Below are the U.S. Nuclear Regulatory Commission (NRC) staff talking points on the Homestake Mining Company of California (HMC), Grants Reclamation Project (GRP) Alternate Concentration Limit (ACL) License Amendment Request (LAR), dated August 8, 2022.

The NRC staff notes that the first number of the comment below corresponds to the chapter or section in the ACL LAR where the comment originates.

Figure 1. HMC's Projected Annual Precipitation for the GRP for the Base Case and Bounding Case (adapted from Figure 4-9 in HMC's ACL Application Appendix 4.2-B)

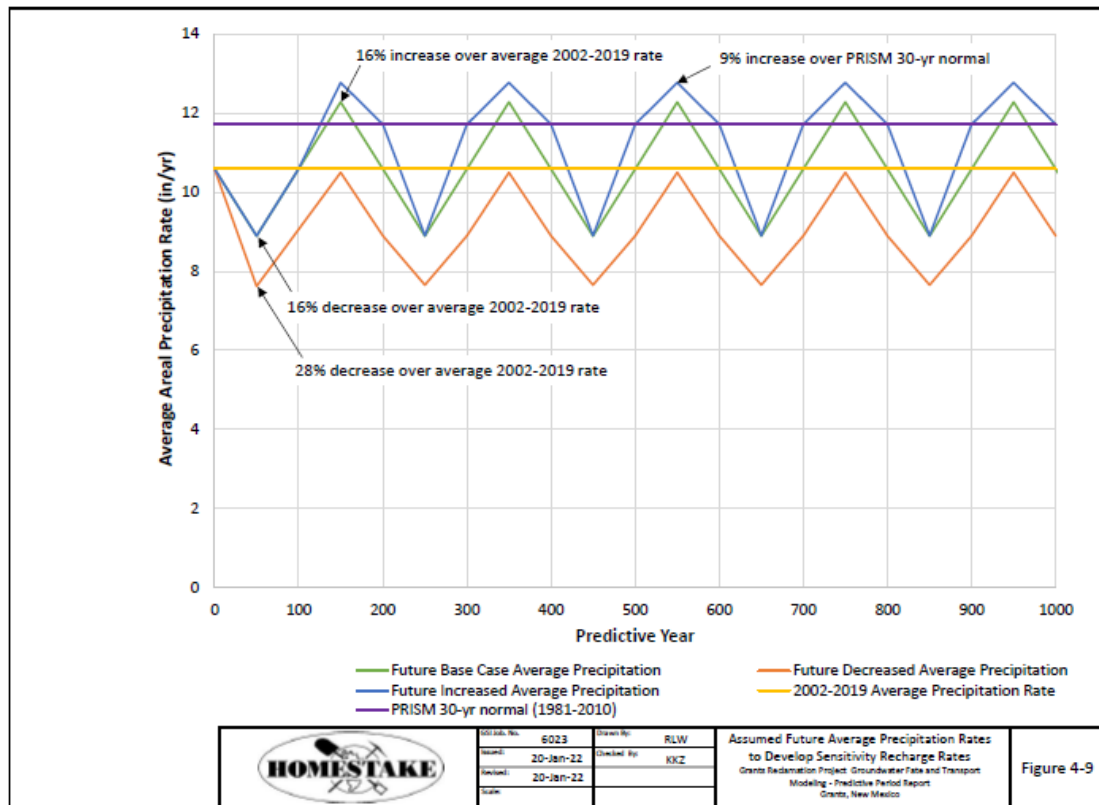
In the ACL application, HMC cited meteorological data from the Grants-Milan Municipal Airport from 1986 through 2018 with an average annual precipitation of 13.6 in/year. However, in the ACL application for the base case condition in the groundwater model, HMC assumed an average precipitation of 10.6 inches/year varied linearly over 200-year cycles from a low of approximately 8.9 inches/year to a high of 12.3 inches/year. In the bounding case condition, HMC assumed an average precipitation of 11.7 inches/year varied linearly over 200-year cycles from a low of approximately 8.9 inches/year to a high of 12.8 inches/year. Figure 1 below shows HMC’s assumed precipitation for the base case and bounding case conditions, as well as a

decreased precipitation case. The values assumed in the groundwater model appear to be more consistent with HMC's GRP meteorological data.

NRC staff is concerned with the significant discrepancy between the reported precipitation from the Grants-Milan Municipal Airport and HMC's GRP meteorological data (i.e., 44% higher annual precipitation at Grants-Milan Municipal Airport than GRP), which are located approximately 5 miles apart. Several factors (e.g., exposure and wind, rain gauge design and evaporation) could be biasing HMC's meteorological data low.

Figure 2. Historic Precipitation for Grants, NM (adapted from WRCC data for Grants, NM)

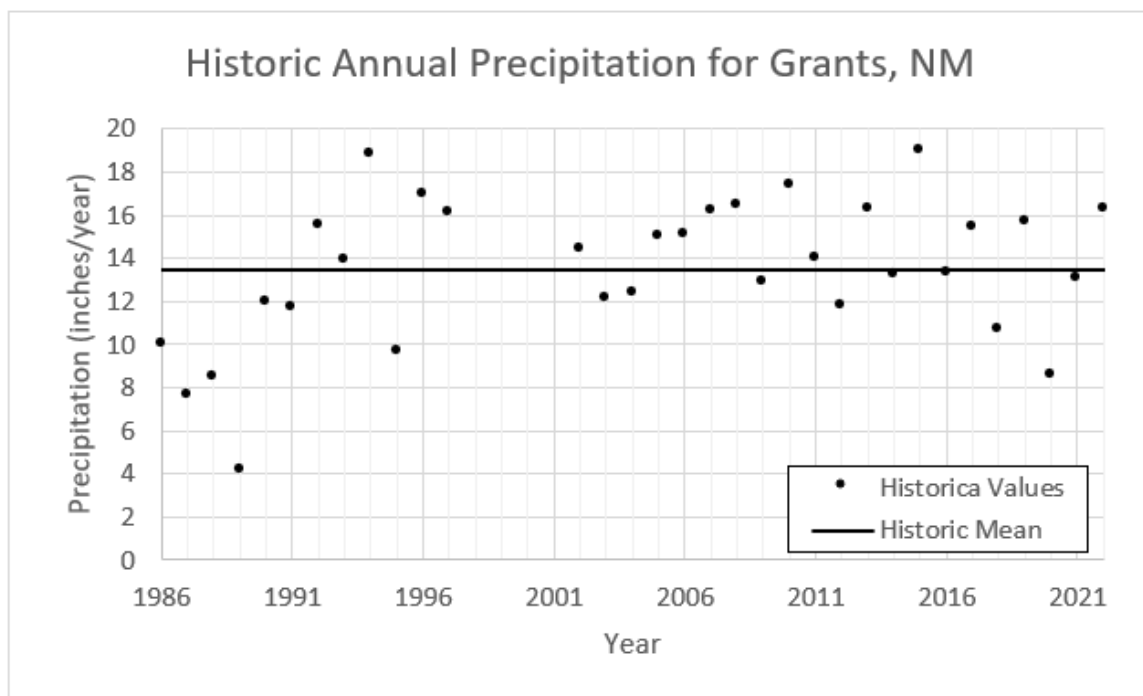
The NRC staff reviewed the Western Regional Climate Center (WRCC) data for Grants, NM, which HMC also relied upon. For the period from 1986 to 2022, annual precipitation averaged 13.5 in/year with a maximum annual value of 19.0 in/year (<https://wrcc.dri.edu/cgi-bin/rawMAIN.pl?nmXGRA>), as shown in Figure 2. These precipitation rates from the Grants-Milan Municipal Airport are plotted against HMC's projected precipitation rates for the proposed base case, bounding case, and decreased precipitation case in Figure 3 below.

Figure 3. Historic and HMC Projected Precipitation for Grants, NM (adapted from WRCC data for Grants, NM and HMC's ACL Application)

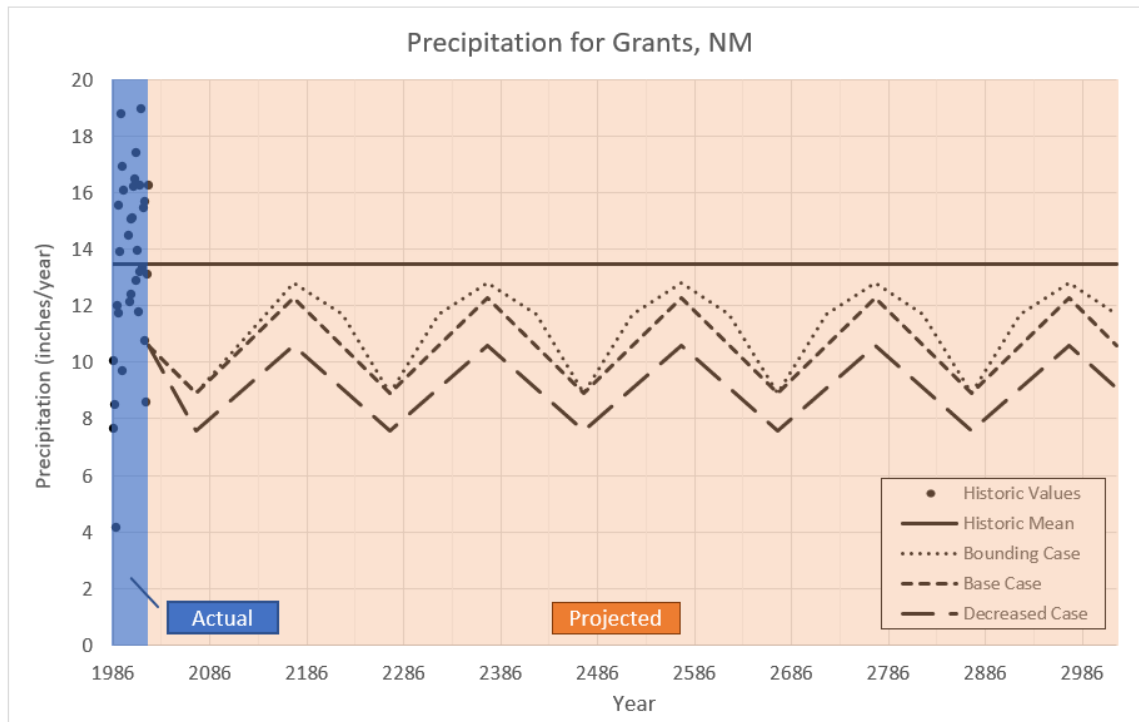
The NRC staff is concerned that HMC selected a range of precipitation rates for the base case and bounding case conditions that was generally less than the recent precipitation rates from 1986 to 2022. Because of the uncertainty in climate projections, the level of support required for the assumption that future precipitation rates will be below the historical average for very long periods of time (e.g., up to 1,000 years) would be exceptionally high. In addition, the assumed below-historical-average precipitation rates appear to be very risk significant as they contribute to a model-projected drying of the alluvial aquifer. This drying of the alluvial aquifer essentially cuts off the plume in the alluvial aquifer from migrating toward the subcrop area with the SAG aquifer. This SAG subcrop area is located near to Milan Municipal wells.

Figure 4. 200-year Predicted Uranium Concentrations for Base Case¹ (adapted from HMC Figure 3-6 of the ACL Application Appendix 4.2-B)

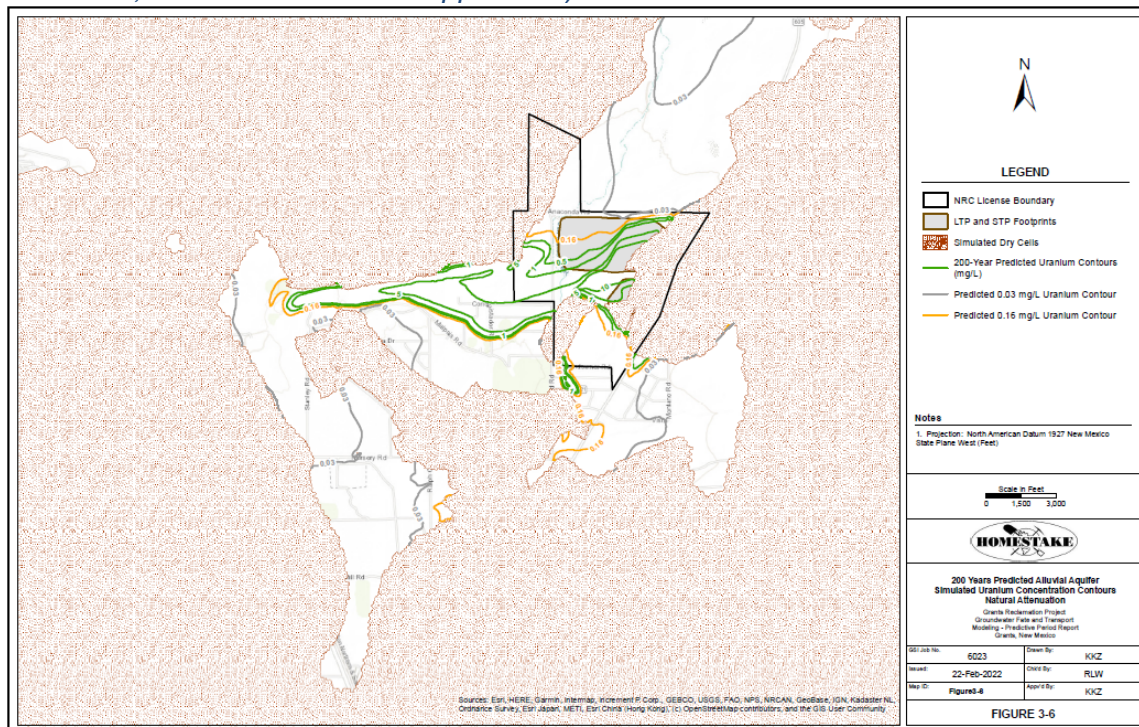
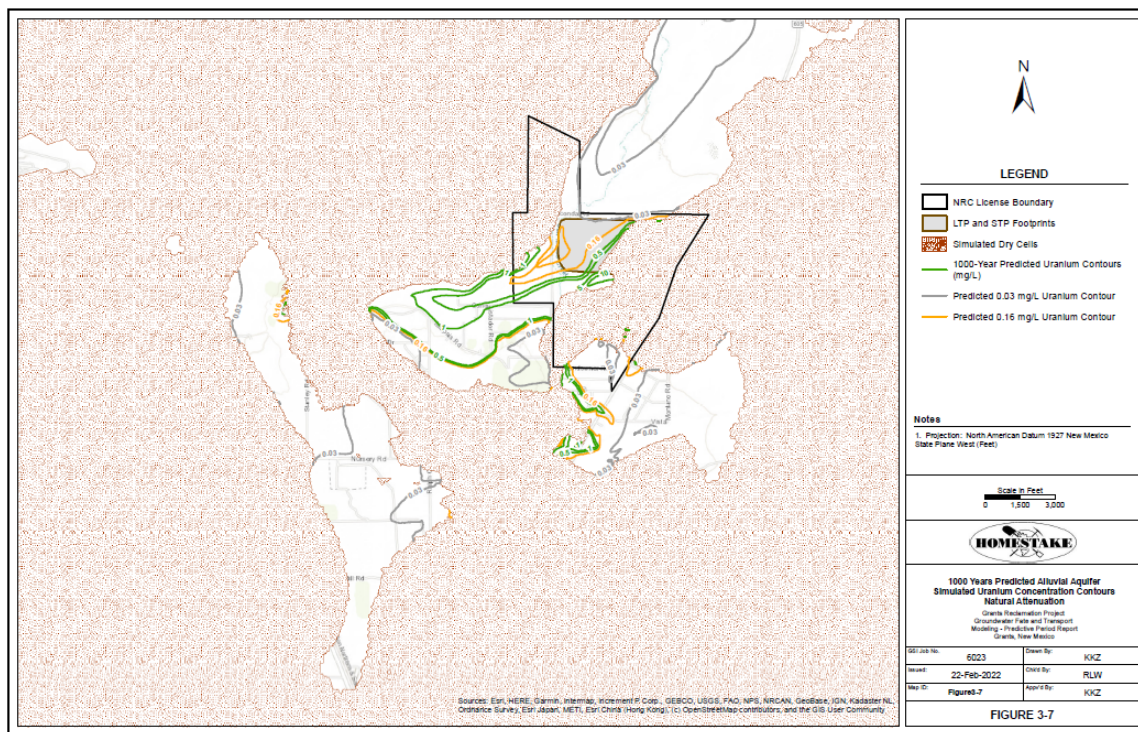
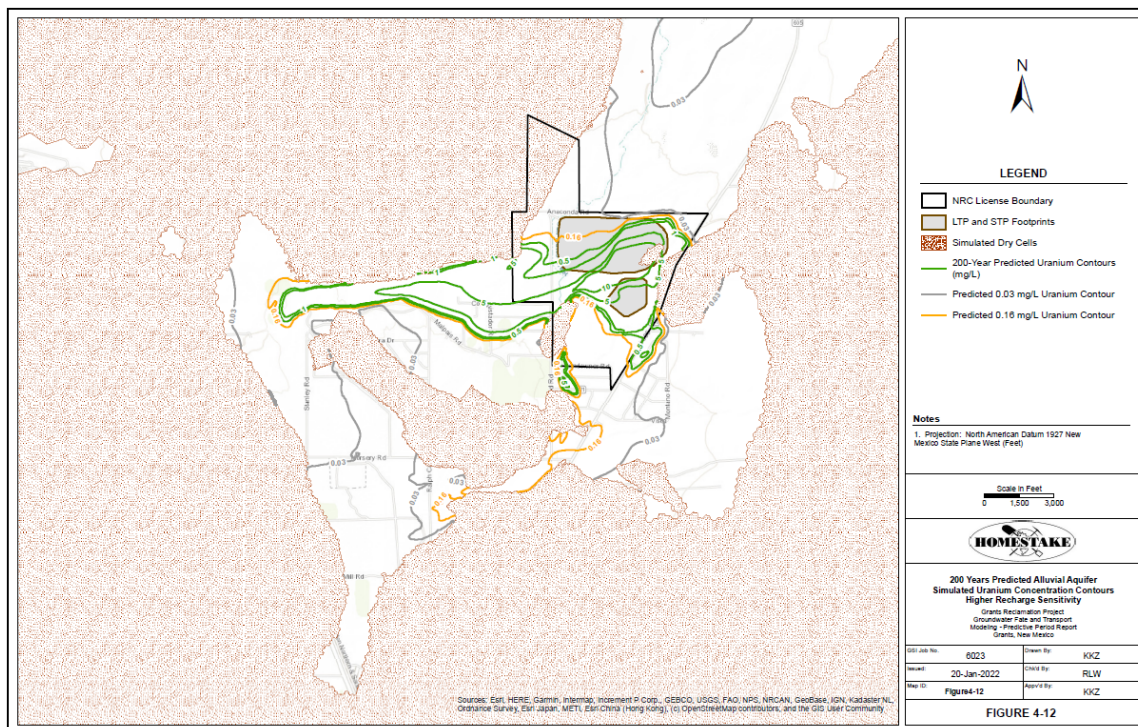
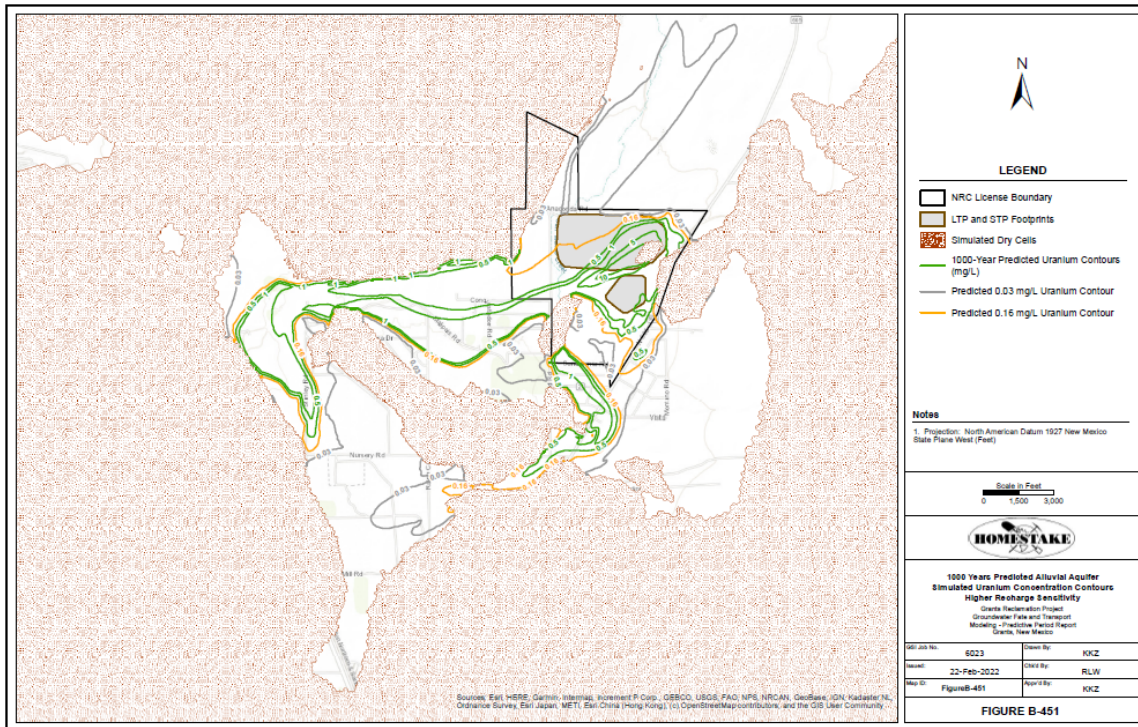
The groundwater model appears to be very sensitive to the assumed precipitation. A comparison of the base case figures (i.e., Figure 4 and Figure 5) with Figure 6 and Figure 7, shows the impact of a slightly higher recharge rate on the drying of the alluvial aquifer. In the base case with natural attenuation, the plume is shown below in Figure 5 as being effectively cut off before 1,000 years as the leading edge of the plume migrates toward the confluence with the Rio San Jose, just upgradient from the subcrop area. However, in the higher recharge sensitivity analysis, the alluvial aquifer remains hydraulically connected to the SAG subcrop area. The NRC staff further notes that HMC's higher recharge rate, which is based in part of the annual precipitation, does not appear to capture the historic average precipitation, as observed at the Grants-Milan Municipal Airport. Figure 7 shows that the leading edge of the plume under HMC's preferred Alternative 3 (i.e., ACLs) could result in impacts to the area where the SAG is in hydraulic communication with the alluvial aquifer. Also, HMC's bounding case, which also does not adequately capture historical precipitation rates at the Grants-Milan Municipal Airport, results in a cutting off of the plume prior to the plume reaching the subcrop area, as shown in Figure 8 and Figure 9 below. Accordingly, the NRC staff is concerned that actual precipitation rates could result in substantially greater impacts than assumed in HMC's ACL application, including impacts to the regional drinking water supply aquifer.

Figure 9. Historic and Modeled Monthly Precipitation for Grants, NM

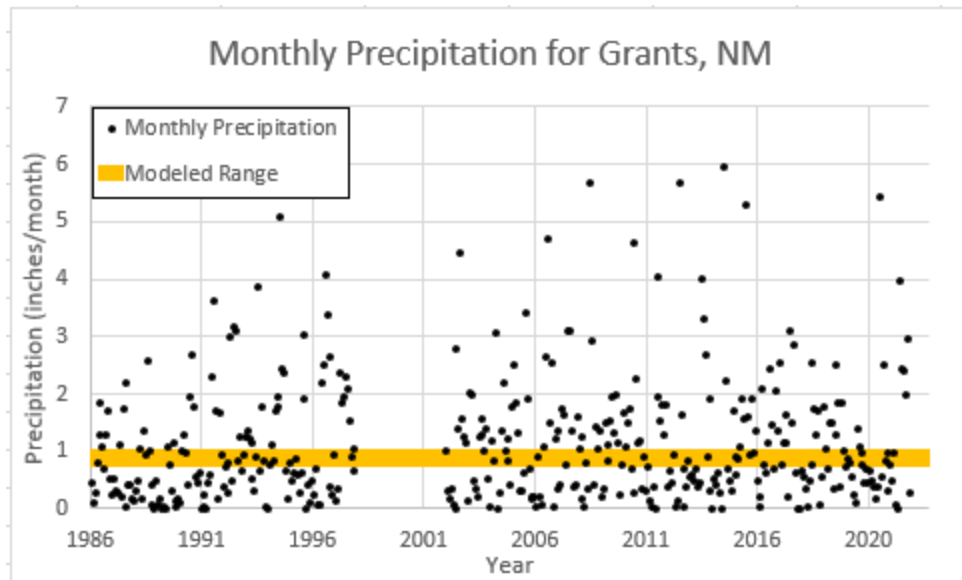
The precipitation rate implemented in the groundwater model is unclear.

It is not clear in the ACL application how the annual precipitation rates are applied in the groundwater model. If the precipitation is temporally averaged (i.e., applied at an annual rate or averaged monthly or daily), then recharge could be underestimated. Even though annual pan evaporation may exceed annual precipitation, episodic events and snowmelt could still result in precipitation percolating into the groundwater. Figure 10 shows the monthly precipitation rates relative to the range of modeled precipitation if the annual precipitation was evenly divided across 12 months. Daily precipitation versus an average annual precipitation would illustrate an even greater disparity. To avoid potentially underestimating recharge, there needs to be some accounting and discussion of how episodic events are addressed within the model.

Figure 10. 200-year Predicted Uranium Concentrations for Back-Diffusion Source Sensitivity Analysis (adapted from HMC Figure 4-15 of the ACL Application Appendix 4.2-B)

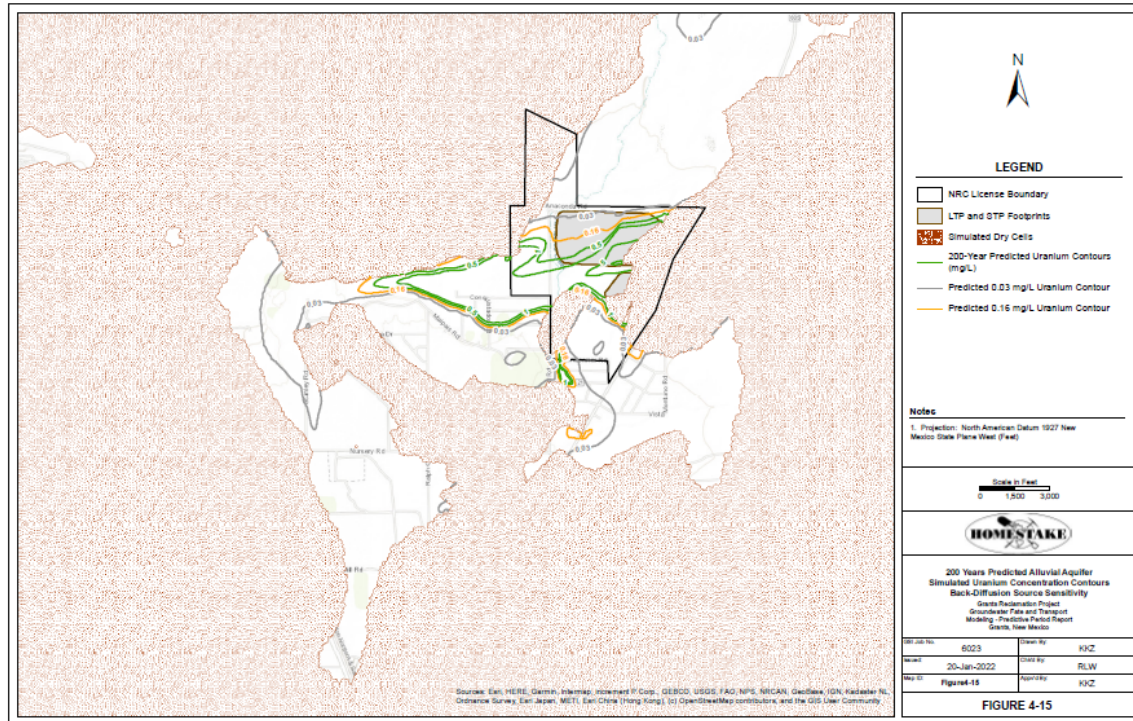
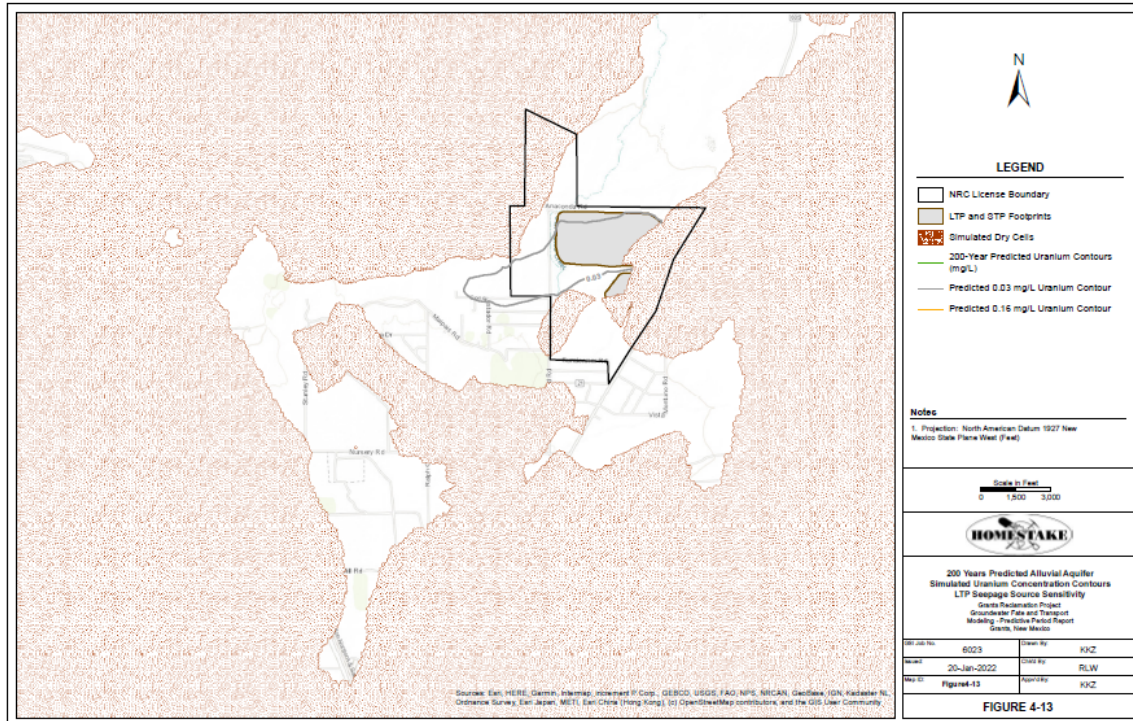
The low-permeability zones, which appear to control the long-term uranium groundwater concentrations, are not adequately characterized in the LAR.

The low-permeability zones in the alluvial aquifer appear to control the long-term uranium groundwater concentrations based on a comparison of the base case (Figure 4), Back-Diffusion Only Source (from the low-permeability zones) Sensitivity Analysis (Figure 11), and the LTP Seepage Source Sensitivity Analysis (Figure 12). HMC discussed that sensitivity analyses indicated that model results were not sensitive to model parameters related to low-permeability zones. However, several model assumptions (e.g., alluvial cell drying) appear to obscure results from these sensitivity analyses. In other words, if parts of the alluvial aquifer are assumed to dry out and plume migration is effectively cut off, then the assumptions related to contaminant transport would not impact the model results. Because the NRC staff has concerns regarding HMC's assumptions that result in cell drying (see Comment 1-3, Comment 1-4, and Comment 1-5) and the low-permeability zones appear to control long-term uranium groundwater concentrations, the licensee will likely need additional characterization information regarding the low-permeability zones, such as:

- Characterization of the presence and distribution of low-permeability zones and high permeability zones;
- Characterization of the uranium mass and concentration in low-permeability zones;
- Characterization of the uranium concentration gradients in the high permeability zones leading to or from the low-permeability zones;
- Characterization of the physical and hydraulic properties of the high and low-permeability zones; and
- Characterization of the mass transfer rates into and out of the low-permeability zones.

Figure 12. Uranium Mass Balance (adapted from Figure 4.1-37 in HMC's ACL Application)

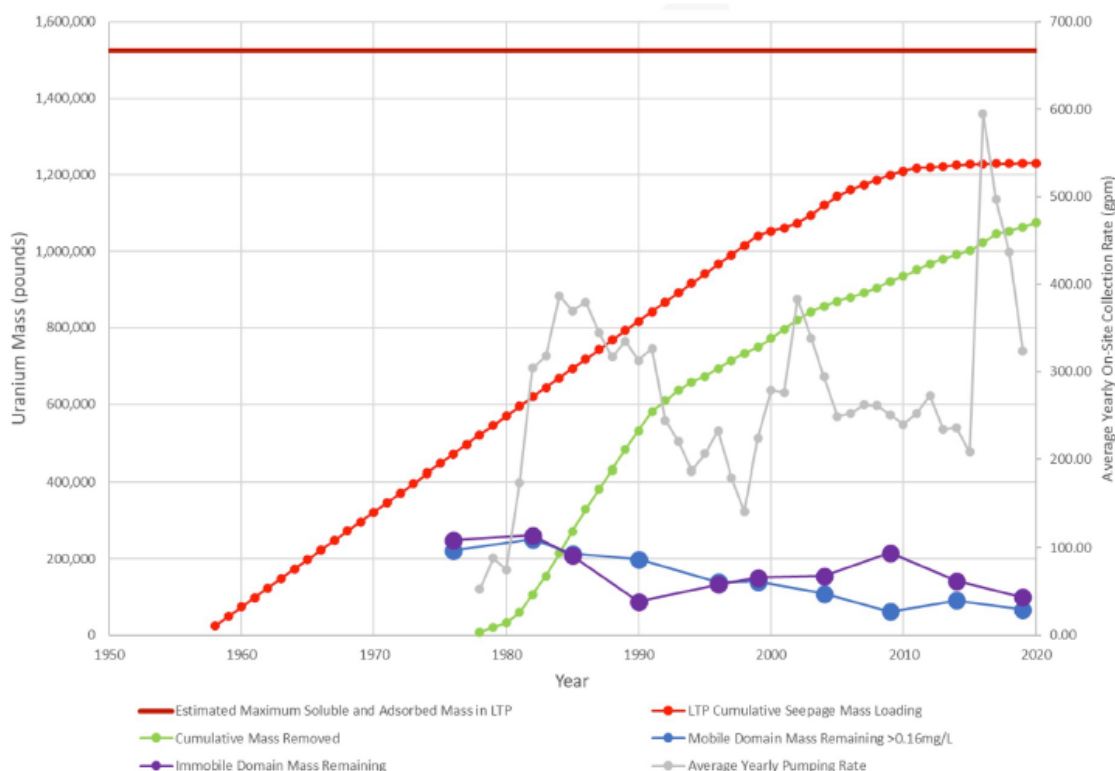
The NRC staff appreciates that there are diminishing returns over time with continuing groundwater restoration corrective action. However, HMC's ACL application shows that a significant amount of uranium continues to be removed from the groundwater at nearly a linear rate, as shown by the green line in Figure 13 below. Furthermore, the onsite groundwater collection rate, which is shown by the gray line in Figure 13 below, has been operated at or below 300 gpm on an annualized average rate for approximately 11 years between 2005 and 2015. During that time, the Reverse Osmosis (RO) capacity was 600 gpm as stated in Section 4.1.3.2 of the LAR. In 2015, the RO system was upgraded and reached a design capacity of 1,200 gpm, however, after a rapid collection rate increase in 2016 to nearly 600 gpm, the collection rate again has rapidly declined to approximately 300 gpm in 2019, as shown in Figure 13. Operating the RO system corrective action at approximately one-half of its capacity for an extended period of time from 2005 to 2015 would have likely hindered removing uranium and other contaminations to the extent practicable and to ALARA. Operational declines after the RO system capacity peaked in 2016 does not support that the RO plant corrective action was operating to remove contaminants at the extent practicable and to ALARA. A defensible groundwater model could indicate that additional groundwater corrective actions are cost effective.
